2006 International Building Code Errata

THIRD PRINTING (Updated December 17, 2007)

FIGURE 1613.5(3)

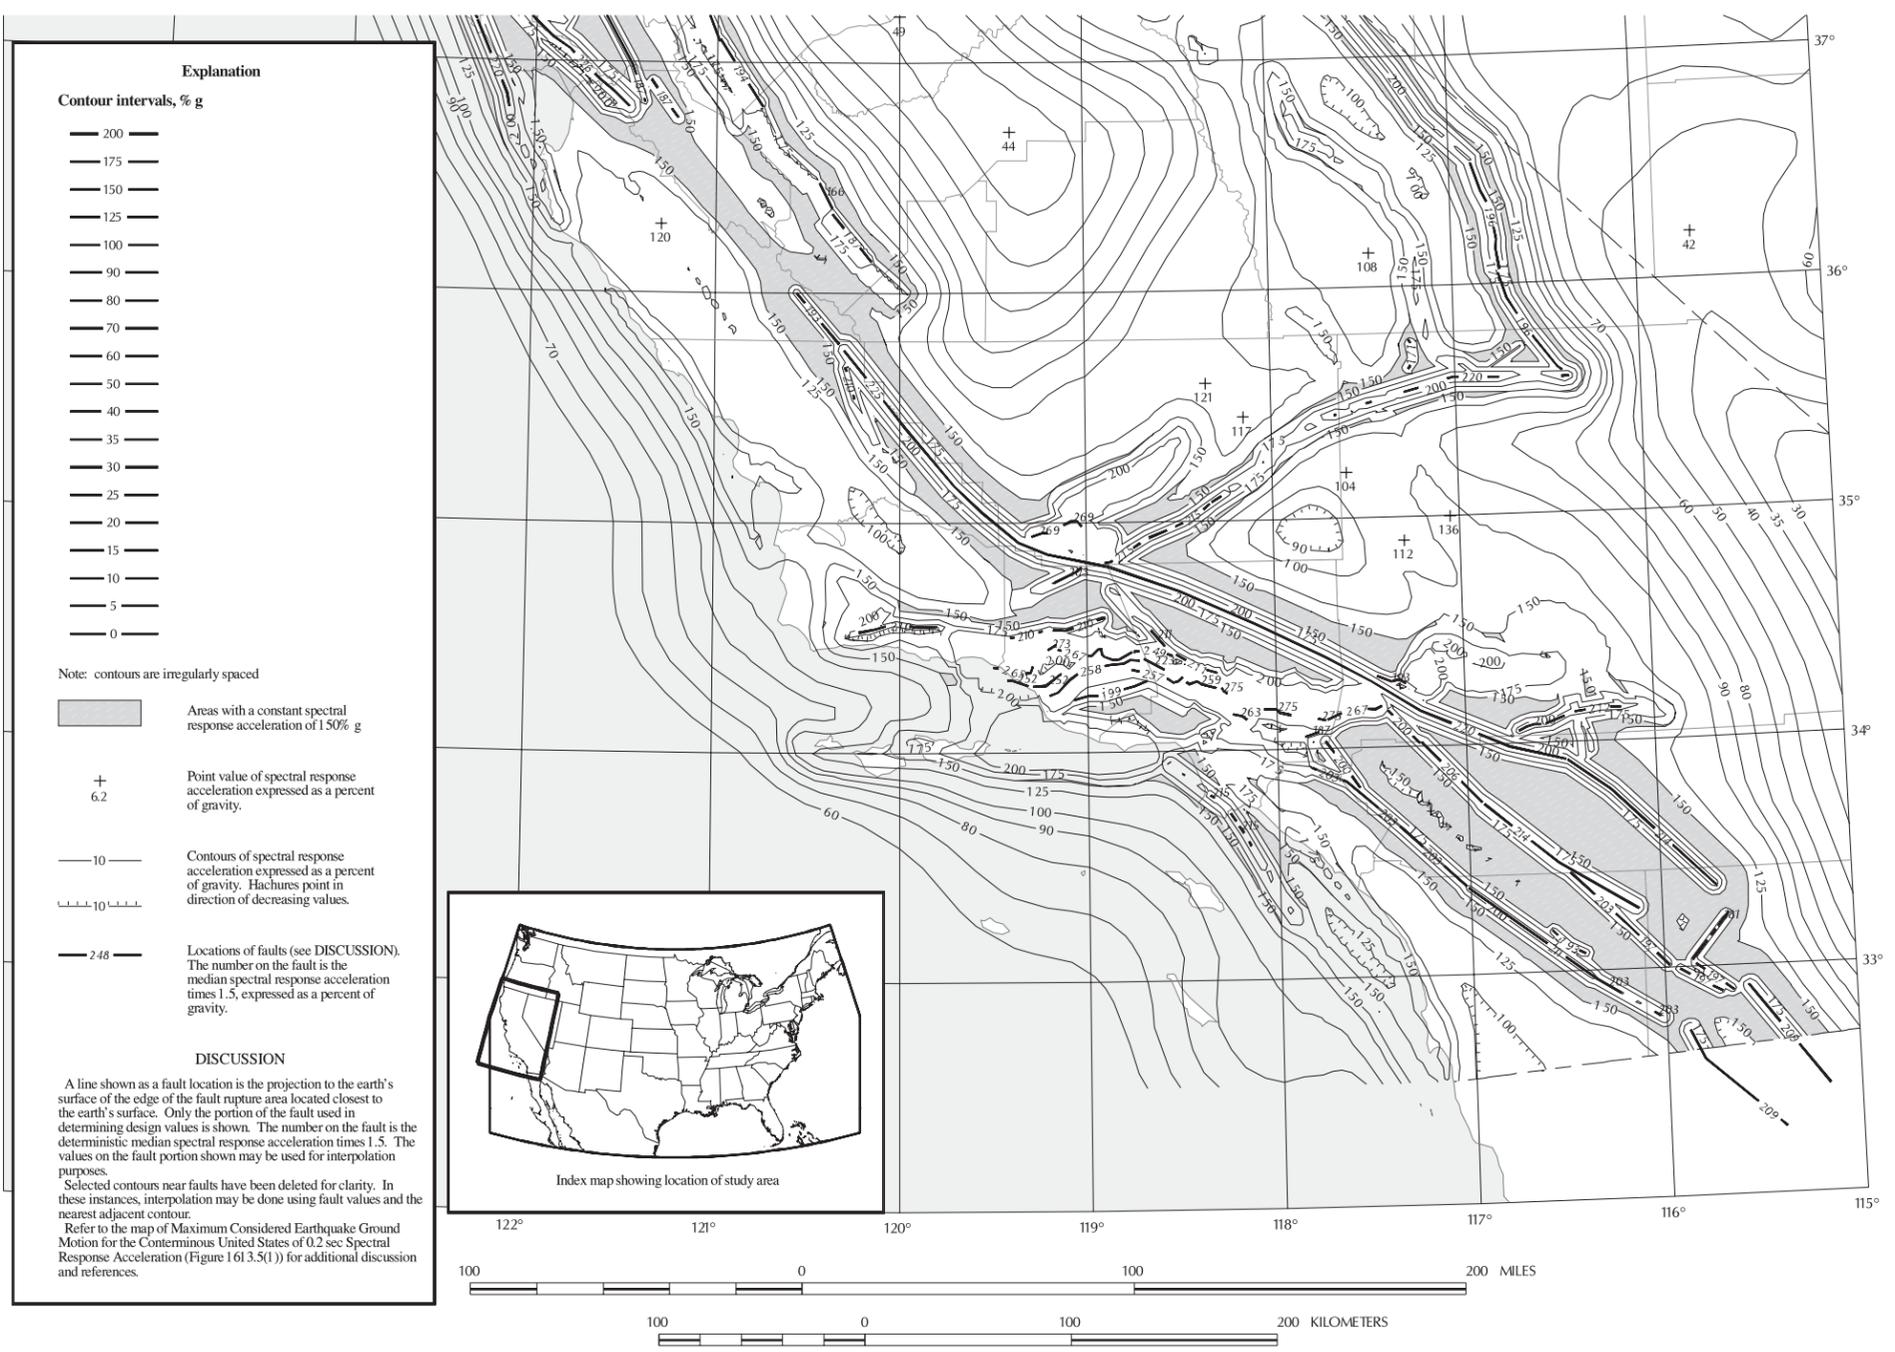
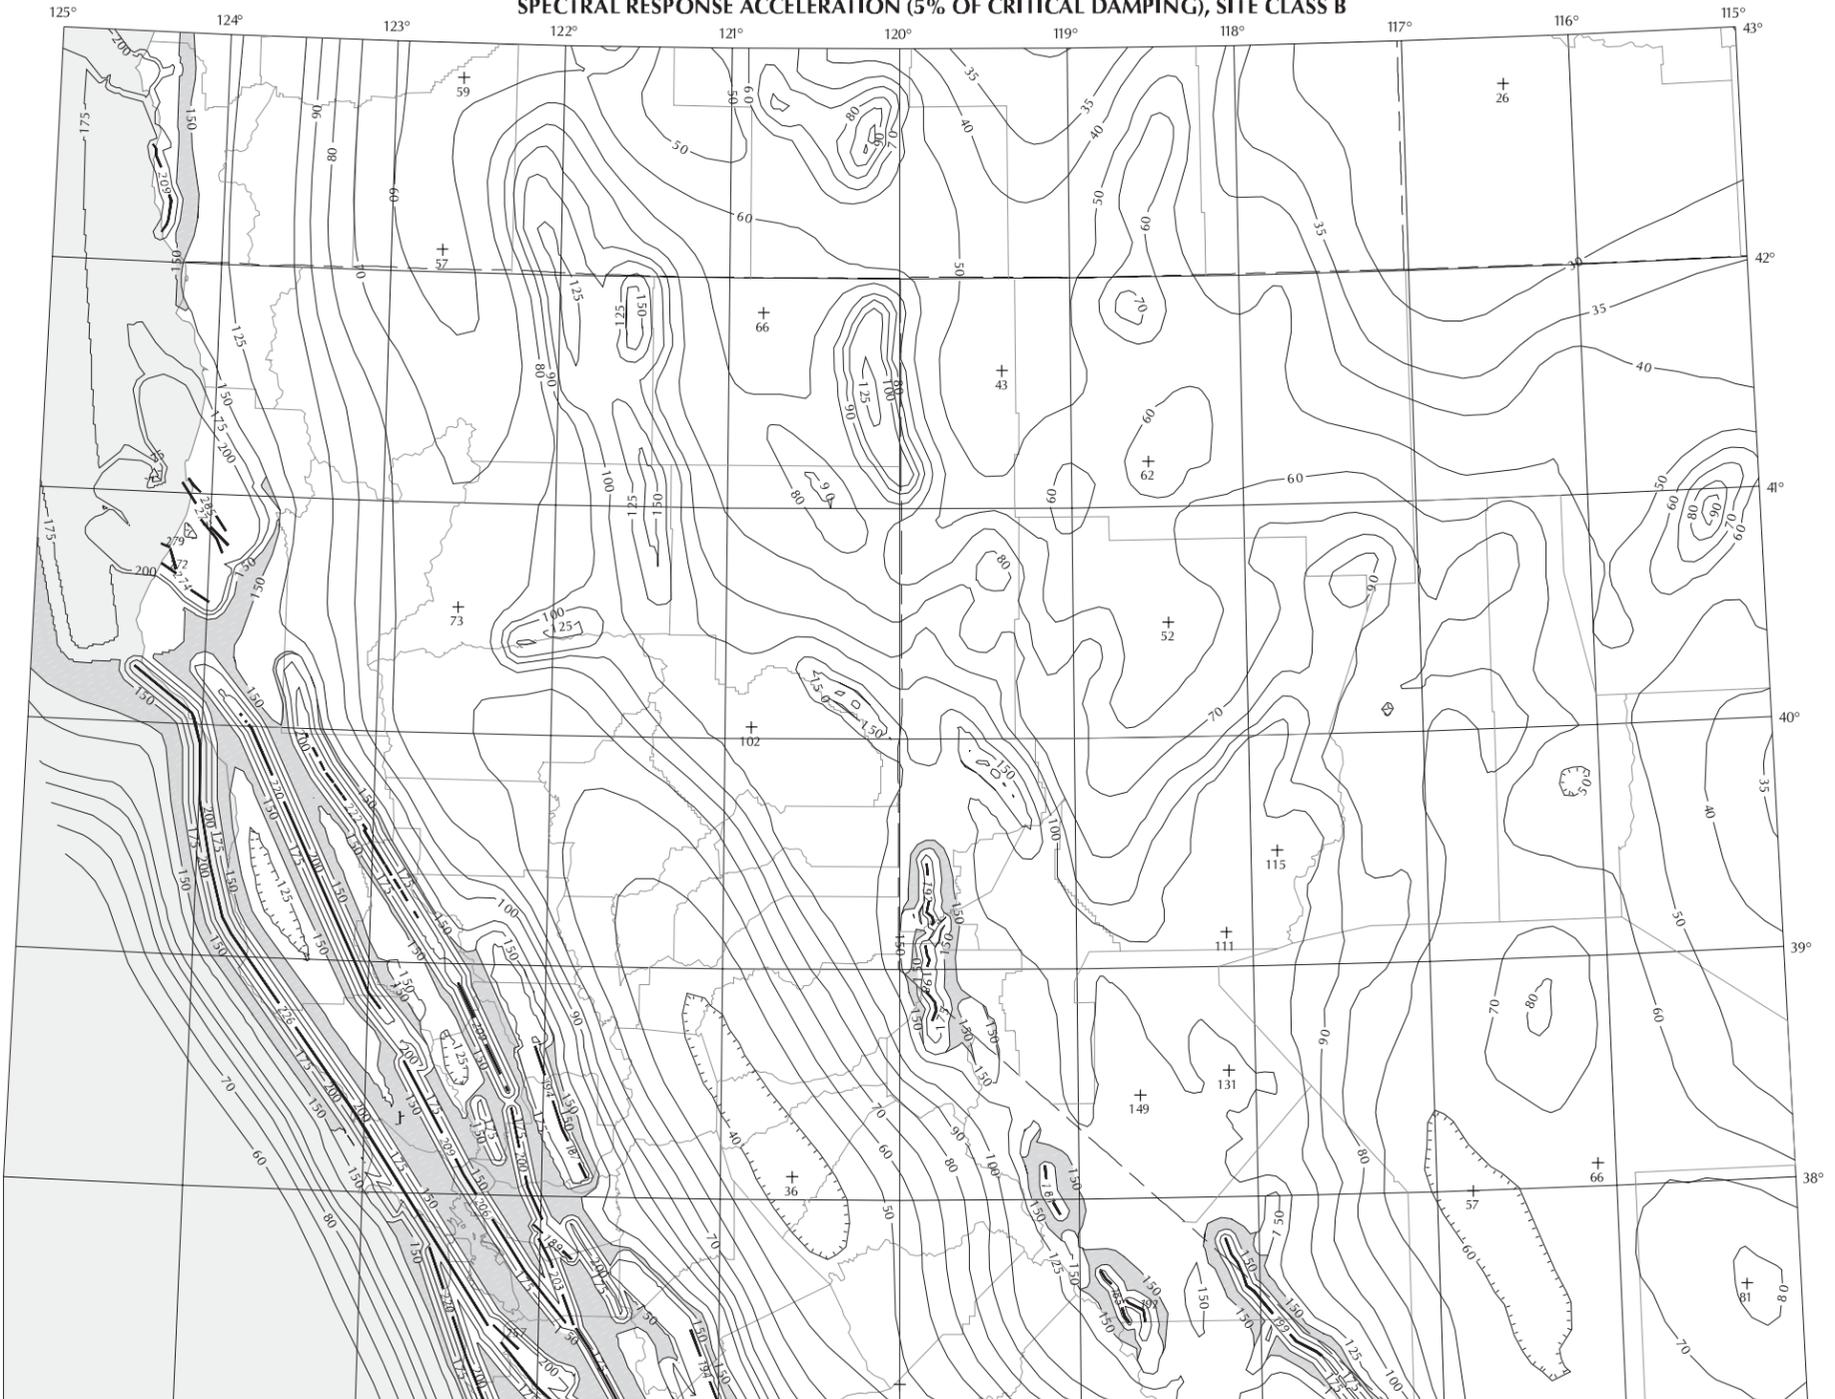
MAXIMUM CONSIDERED EARTHQUAKE GROUND MOTION FOR REGION 1 OF 0.2 SEC SPECTRAL RESPONSE ACCELERATION (5% OF CRITICAL DAMPING), SITE CLASS B *(posted 12-17-07)*
